TECHNICAL BULLETIN: TB17-01

Subject: Steadi-Flex Heavy Duty – needed clearance for trailers with Top Mounted Couplers

Product Family
Steady-Flex Heavy Duty

Applications
66559
66560
66561

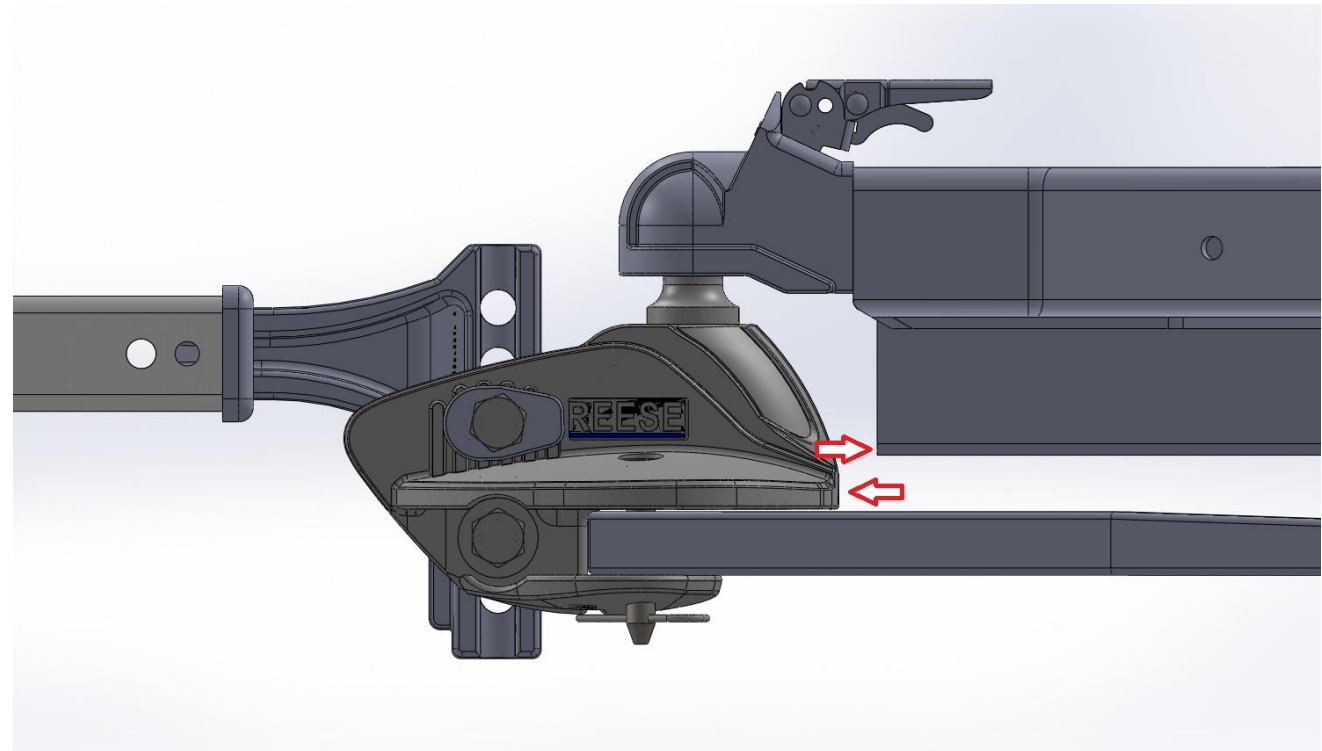
Trailers with Top Mounted Couplers – clearance between the Steadi-Flex ballmount and trailer frame rail is needed to eliminate potential contact shown at arrows below. See chart on page 2.

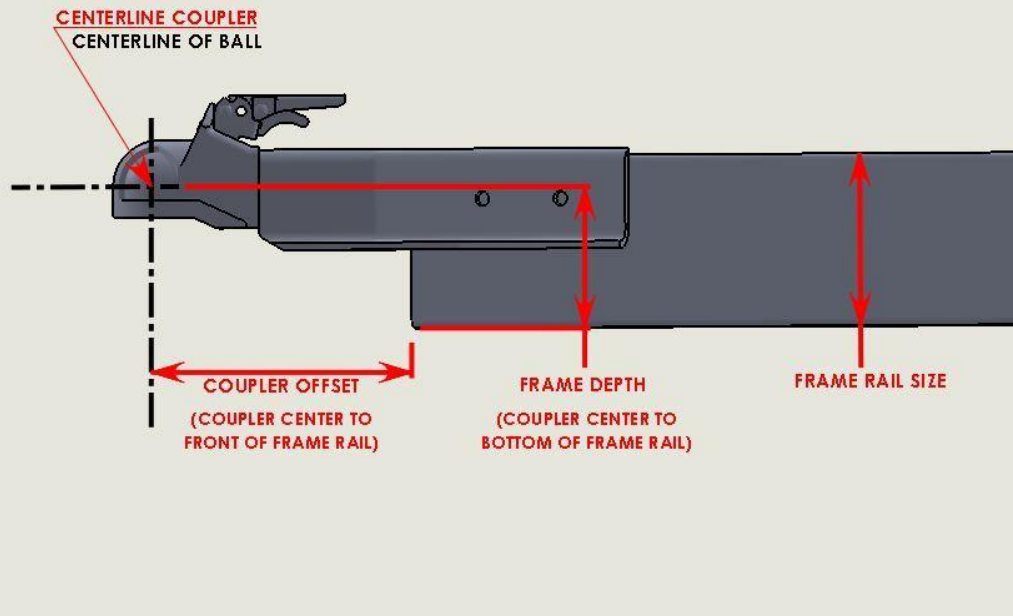
This pertains to top mount couplers only. Any bottom-mount coupler with a 4"-7" frame will work without issue.

These values are general guidelines for frame sizes and coupler heights assuming straight level installation. Chain loops and other brackets or accessories are included in the Coupler Offset dimension and must be clear of the Coupler Offset area or modified.

For intermediate measurement conditions between green and red, ensure at least 3/4" clearance between ballmount and trailer frame rail / accessories. For frame rail depth over 5", this includes during steering on flat ground.
